### WILLIAMSON COUNTY, TEXAS CHANGE ORDER NUMBER: 4

| 1. CONTRACTOR: Dan Williams Company  |  | Prujed Rock TB Grwegostion  |
|--|--|---|
| 2. Change Order Work Limits: Sta. 9+00 to  | Sta. 12+00   | Roadway: O'Connor Dr Ext  |

### Williamson County Road Bond Program O'Connor Drive Extension Williamson County Project No. 11WC906

### Change Order No. 4

| -    | UPDATED     | UPDATED GUANTITIES  |    | 47.5011 |
|------|-------------|---------------------|----|---------|
| 7    | WEDTAN A    | WODIFICATION        | П  | 11/2011 |

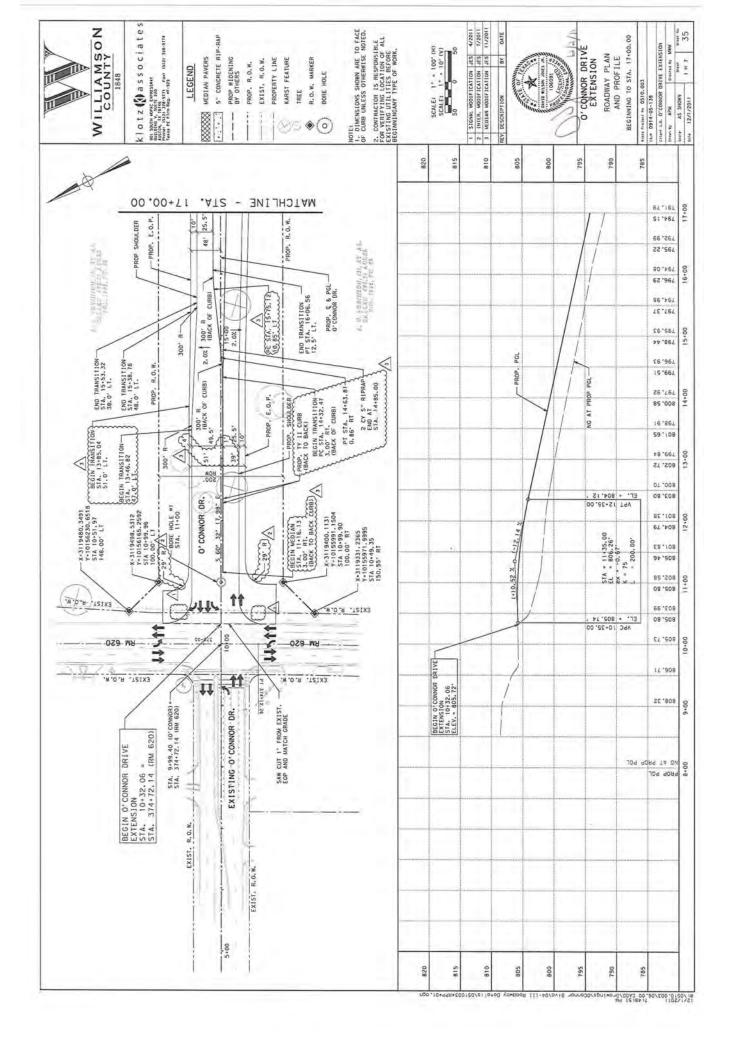
The alignment of the roadway and the width of the center median were changed so that the striping layout of the lanes south of RM 620 line up with the striping layout of the lanes north of RM 620. The center median width was reduced from 7.5 LF to back to back curbs in order to achieve the alignment, which also reduces the quantity of landscape pavers needed on the project. The embankment in this area had already been constructed in accordance with the original plans and will be removed and replaced with flex base where the center median is narrowed. This Change Order also provides a new Contract item for hand forming curb, since one side of the median curb cannot be slipformed because the curbs are back to back.

159-1 1 159 2 TEMP SIGNAL WOOLF ICATION JES 4/2011 7/12/19 ELECTRICAL SCHEDULE O'CONNOR DRIVE EXTENSION REV DESCRIPTION Janes

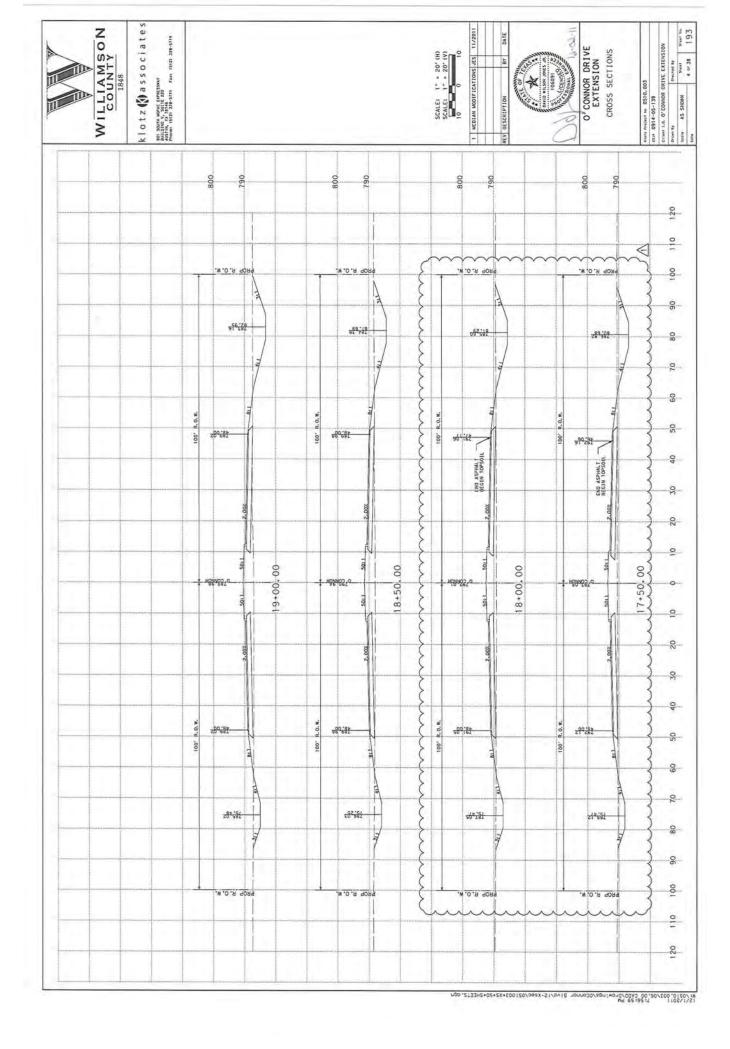
The permanent mast arm signals at O'Connor and RM 620 will be replaced with temporary strain wire signals. The original O'Connor plans called for installation of mast arm signals that would have been removed and replaced with the temporary signals for construction of the RM 620 widening. Signal materials that were already acquired by the Contractor will be purchased by the County for use on the RM 620 Improvements Project. A force account for signal maintenance is also being added to the Contract.
